Well Name: VAUGHN	Well Location: T26N / R6W / SEC 26 / SESE / 36.45314 / -107.43161	County or Parish/State: RIO ARRIBA / NM
Well Number: 8E	Type of Well: CONVENTIONAL GAS WELL	Allottee or Tribe Name:
Lease Number: NMSF079266	Unit or CA Name:	Unit or CA Number:
US Well Number: 3003923854	Operator: HILCORP ENERGY COMPANY

Sundry ID: 2834768

Type of Action: Recompletion

HILCORP ENERGY COMPANY
VAUGHN 8E
MESA VERDE RECOMPLETION SUNDRY

VAUGHN 8E - Proposed Schematic

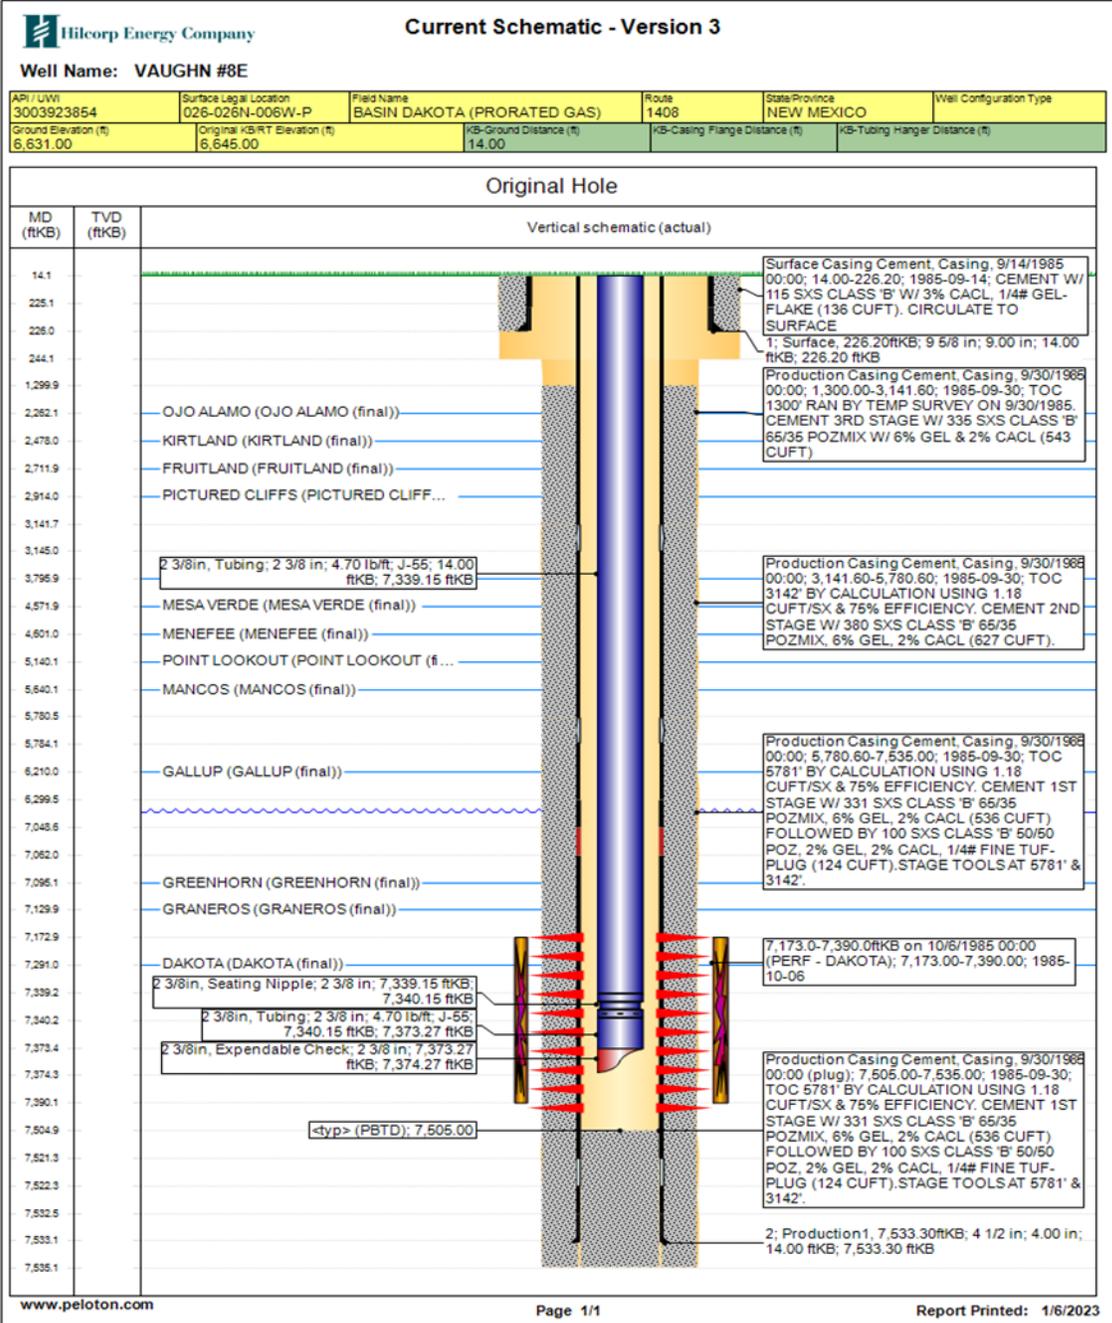
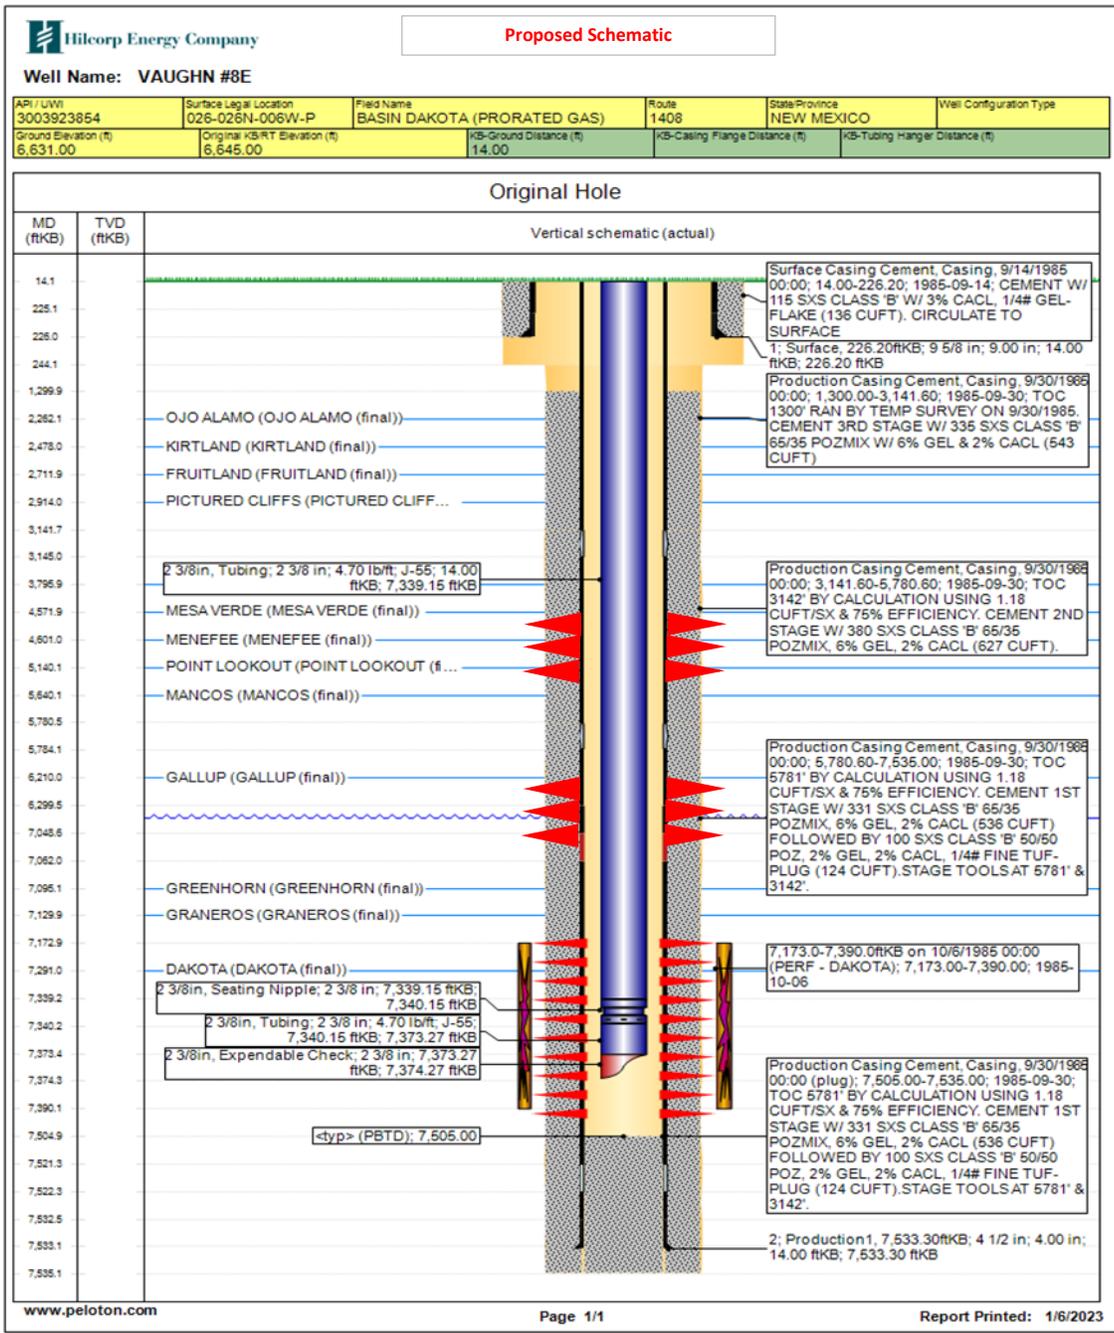
Procedure Description: Hilcorp Energy Company requests permission to REVISE the previously approved recomplete NOI to expand the perforation ranges within the Gallup. We will continue to recomplete within the original Gallup/Mesaverde formations. Please see the attached REVISED procedure, current and proposed wellbore diagram, plat and natural gas management plan. A closed loop system will be used. Hilcorp will contact the FFO Surface group within 90 days after the well has been recompleted, before any interim reclamation work, to conduct the onsite. A reclamation plan will be submitted after the onsite.

4. RU Wireline. Run CBL. Record Top of Cement.
5. Load the hole and pressure test the casing.
6. N/D BOP, N/U frac stack and pressure test frac stack.
7. Perforate and frac the **Gallup** formation (Top Perforation @ **6,211'**; Bottom Perforation @ **6,718'**).

8. Isolate frac stages with a plug.
9. Perforate and frac the **Mesa Verde** formation (Top Perforation @ **4,629'**; Bottom Perforation @ **5,404'**).
10. Isolate frac stages with a plug.
